**RE: Rio Grande Apartments
2211 Rio Grande Blvd. NW
Grading and Drainage Plans
Engineer's Stamp Date: No Date
Hydrology File: H12D024**

Based upon the information provided in your submittal received 09/07/2021, the Grading & Drainage Plans **are not** approved for Building Permit, Grading Permit and SO-19 Permit. The following comments need to be addressed for approval of the above referenced project:

SEAL	DESIGNED	MEC	PROJECT	NO
	DRAWN	MEC	SCALE	NOTED
	CHECKED	VAM	DRAWING	NO
	REVIEWED		C-101	
	DATE	8/2/21		_____ OF _____

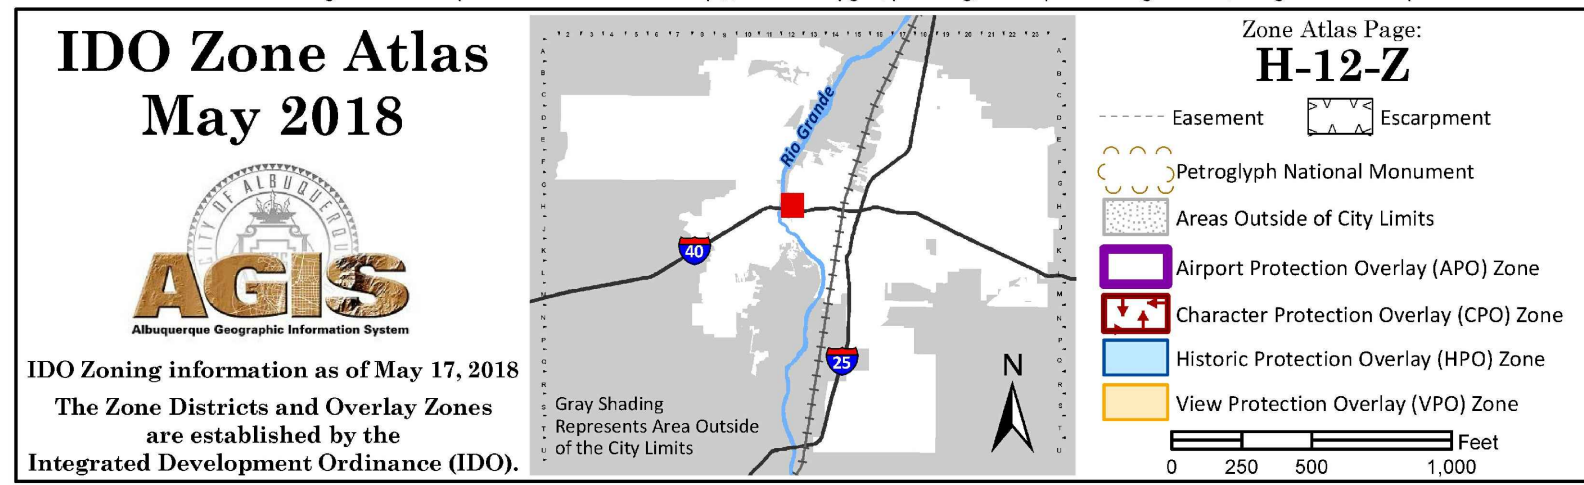
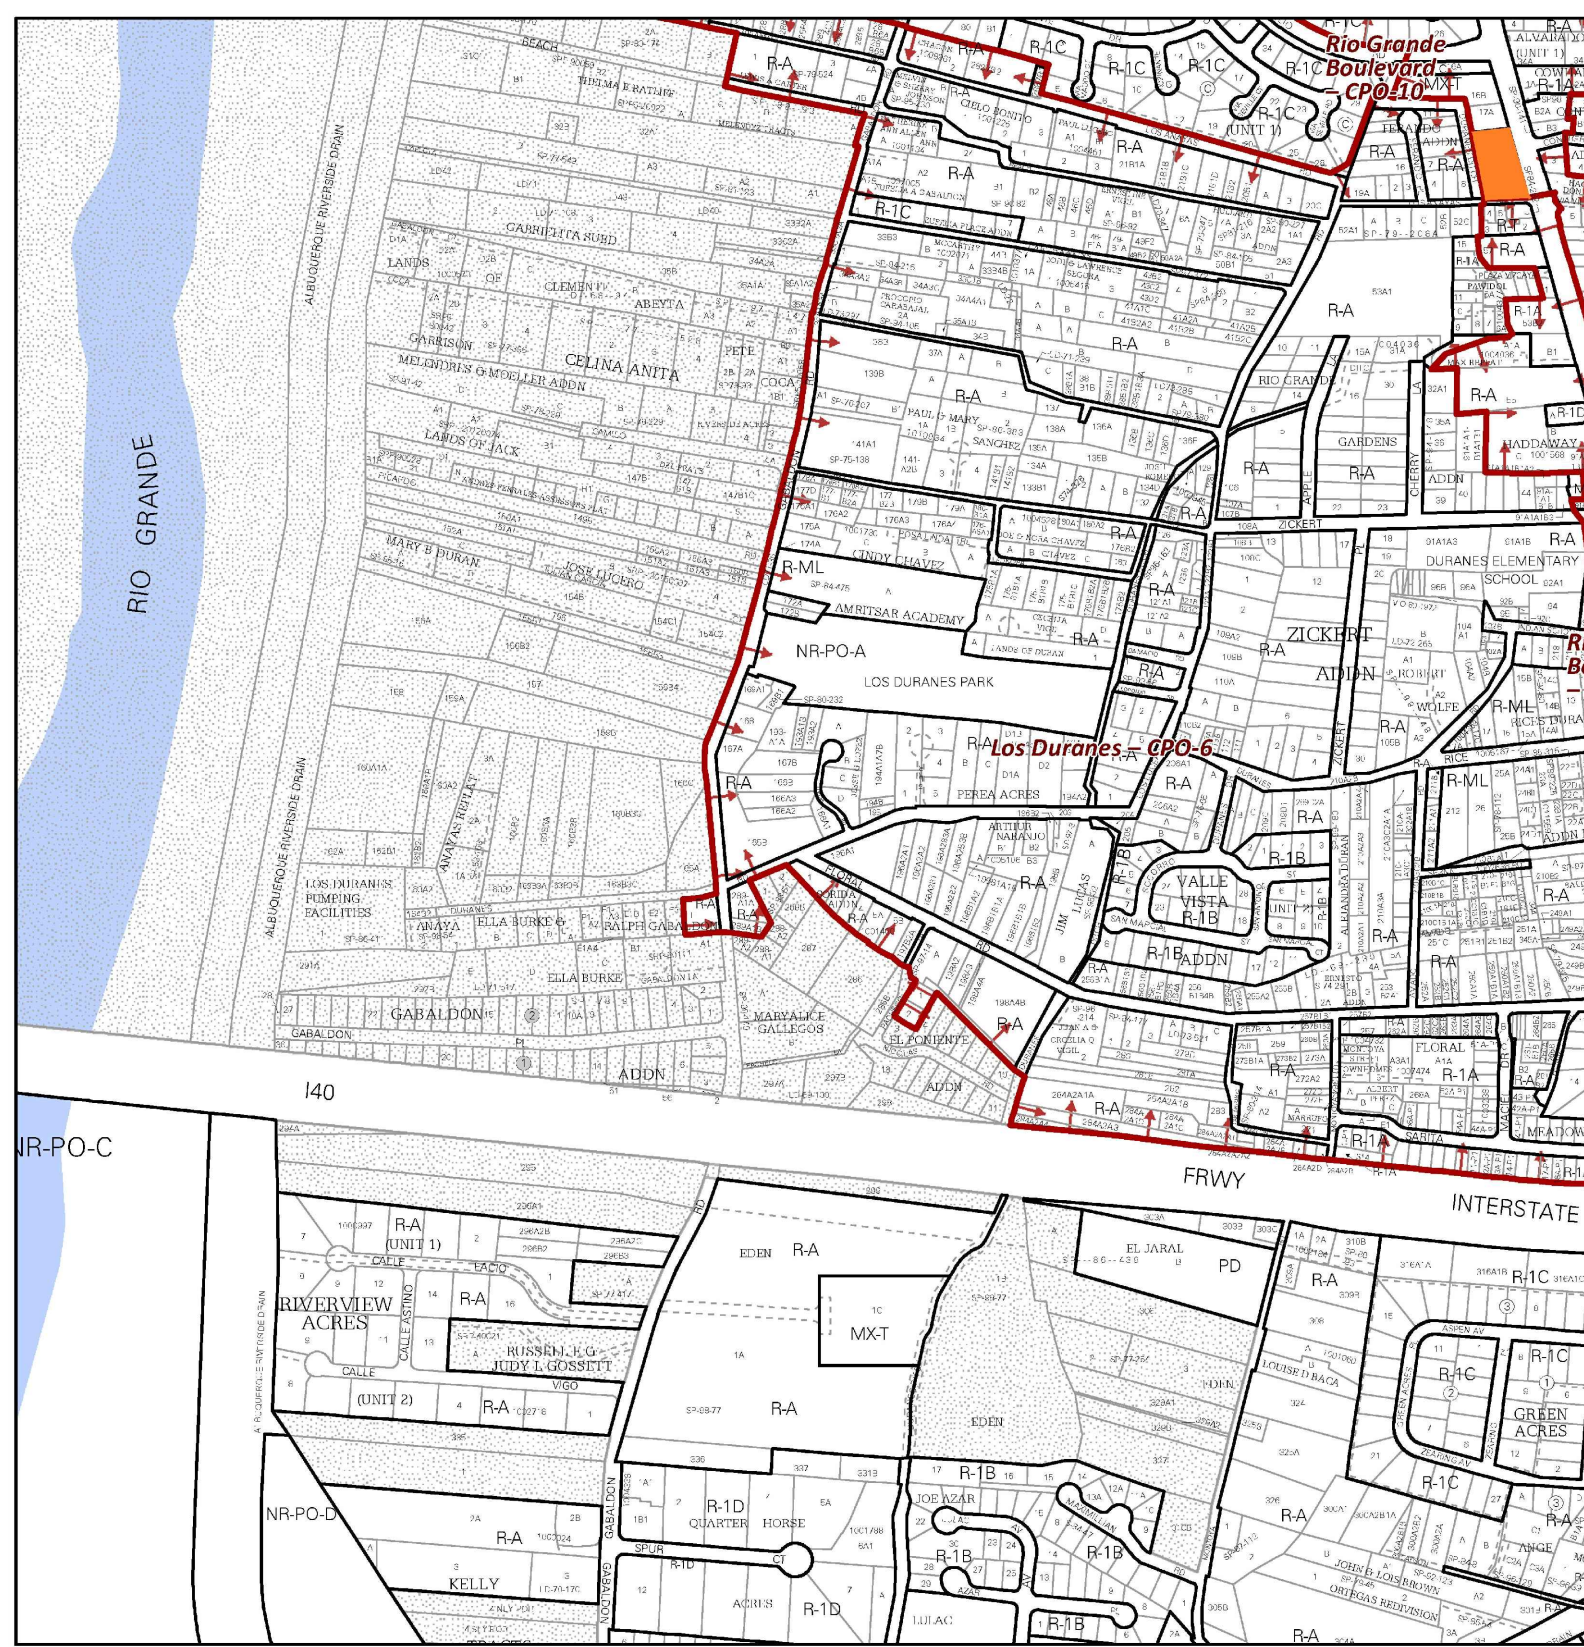
3. Please provide a legal Description of the property.
4. Existing Conditions. This site is in FEMA's Zone X Protected by Levee. (please fix note #9 of the General Notes as well) Also, the site is relatively flat and does not drain.

5. Proposed Conditions. Please remove all references to the County. This site needs to follow the City's current DPM and since this site is in the Valley region, please follow Article 6-5 Valley Drainage Criteria.
6. Please provide the weir calculations, per DPM Article 6-16(A), for the curb cuts and sidewalk culverts. A coefficient of 2.7 is typically used for the weir equation $Q = CLH^{2/3}$.

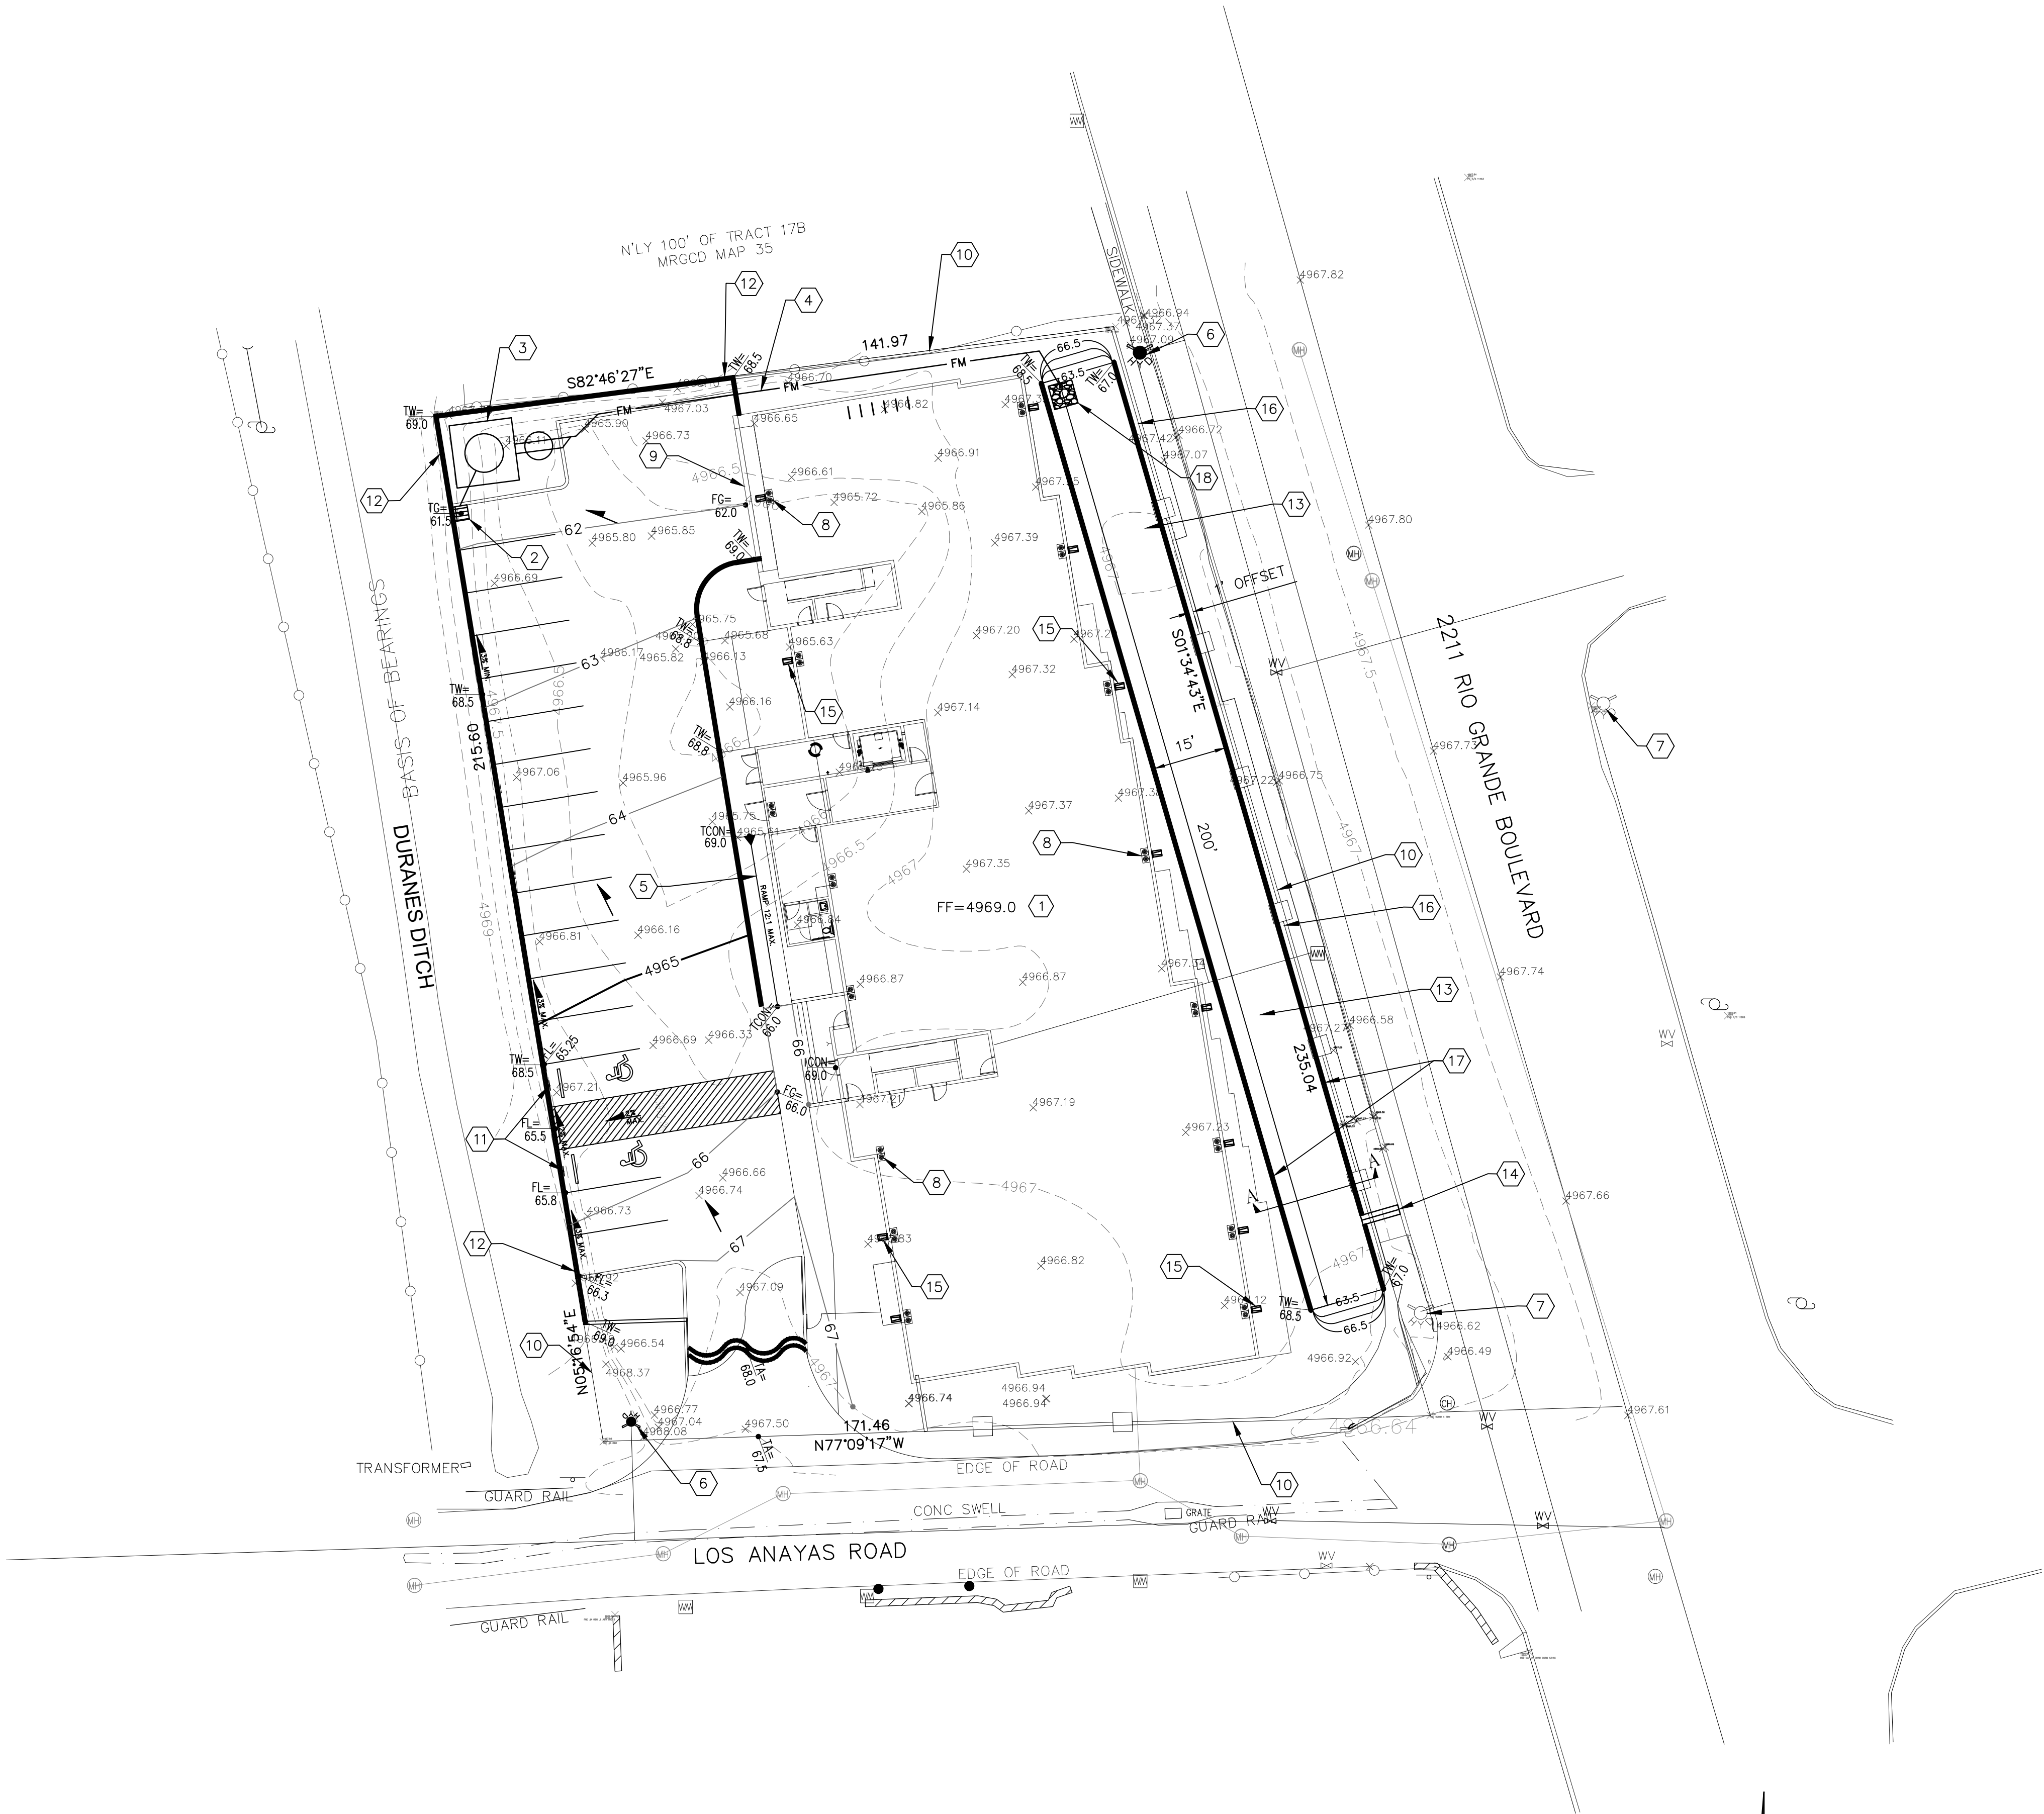
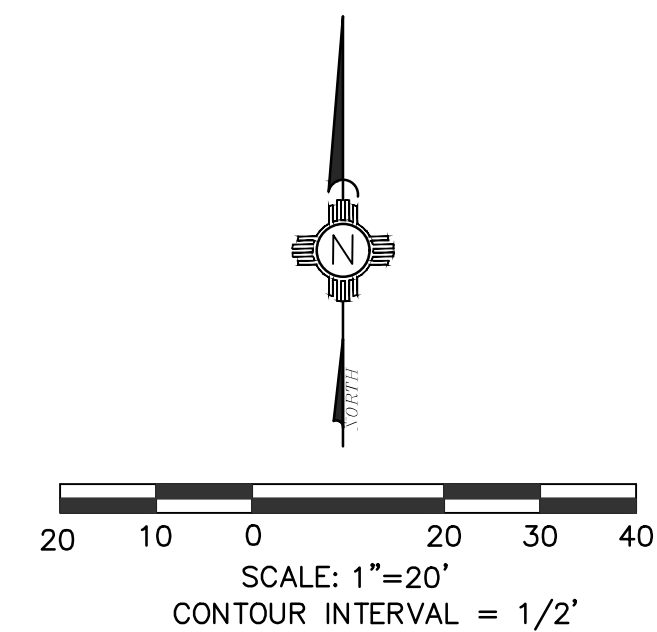
7. Please verify with Transportation. Along Los Anayas Road, this project will be responsible to install curb & gutter and sidewalk per the IDO.

8. Please remove Conceptual for the title of the Grading Plan.

9. Please provide a cross section for the retaining wall along the west and north property lines showing proposed retaining walls, property/ROW lines, existing and proposed grades. In accordance with DPM, grading and wall construction near the property line may not endanger adjacent property or constrain its use. Please make sure that the footer for the wall stays within the project's property. Please provide this section on this Sheet.

10. Please move the cross section of the retention pond from Sheet C-501 to this Sheet. Also please refer to comments under Sheet C-501 for corrections to this cross section.
11. With the confirmation of Comment #5, a waterblock, 0.87' high, per COA Paving Detail No. 2426, is required at the driveway entrance.
12. Please provide the most current SO19 Notes for the sidewalk culvert.
13. Key Note 14 should refer to City of Albuquerque standard detail No. 2236 – Sidewalk Culvert with Steel Plate Top.
14. Please provide invert information for the sidewalk culvert both at the retention pond and at the curb.
15. Please identify all underground utilities shown within the streets.
